Type 1 Required
MODIFICATION INSTRUCTIONS
for Service Codes: 3434 and 3425

Kodak X-Omat 3000 RA PROCESSOR
Mod No. 1

Kodak X-Omat 5000 RA PROCESSOR
Mod No. 3

To help prevent the possibility of film jams in the FIXER/WASH CROSSOVER, due to swelling of the ROLLER, and to install the latest version of software.

Figure 1 **3000 RA PROCESSOR**, Replacement of the “A” ROLLER — See Page 4 for the 5000 PROCESSOR

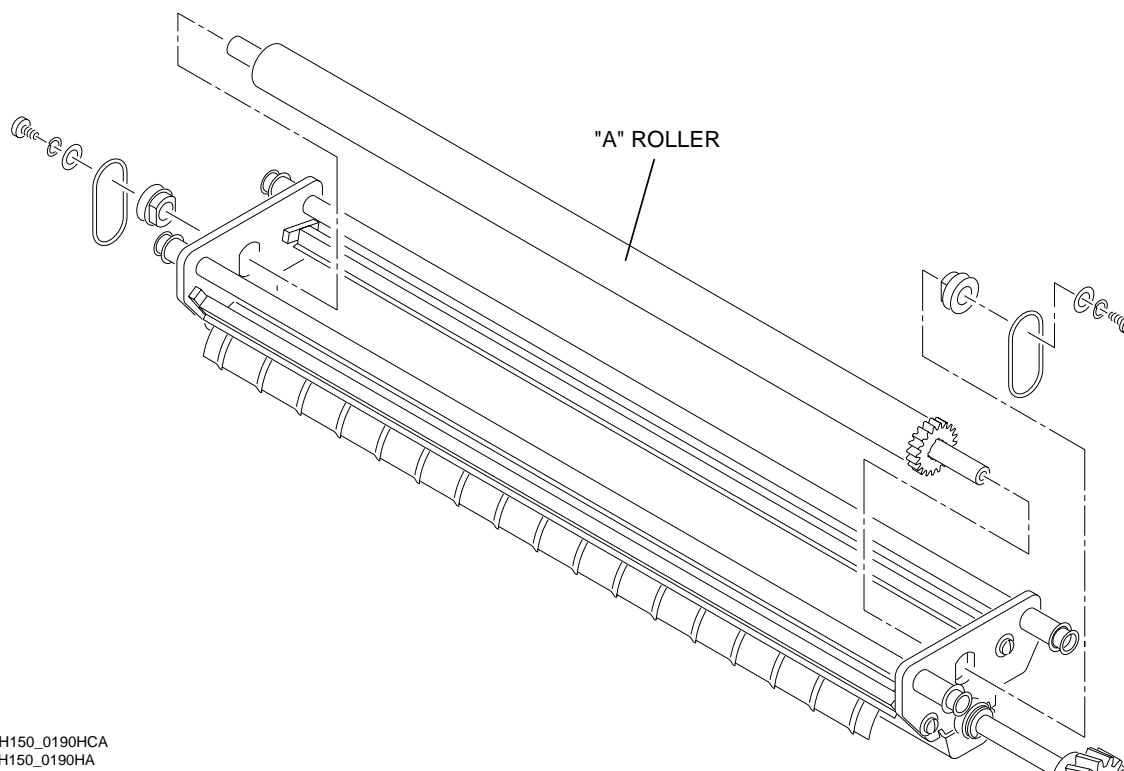
1. Remove the existing "A" ROLLER from the FIXER/WASH CROSSOVER.
 - See Figure 1 for the 3000 RA PROCESSOR on Page 3.
 - See Figure 2 for the 5000 RA PROCESSOR on Page 4.
2. Install the new "A" ROLLER from the Mod Kit.

ROLLER 9B8662 does not substitute for 467017 in all positions in the 3000 and 5000 PROCESSORS, only in the “A” position of the FIXER/WASH CROSSOVER.

3. Change the Part No. for the new “A” ROLLER in the Figures in the Parts List, and add the new Part No. to the Numerical and Alphabetical Indexes:

Old Part No.	New Part No.	Description	3000 RA Processor	5000 RA Processor
			Affected Pages	Affected Pages
467017	9B8662	“A” ROLLER - FIXER/WASH CROSSOVER <u>only</u>	2-5, 3-23, 9-4, and 10-7	2-3, 3-23, 9-4, and 10-6
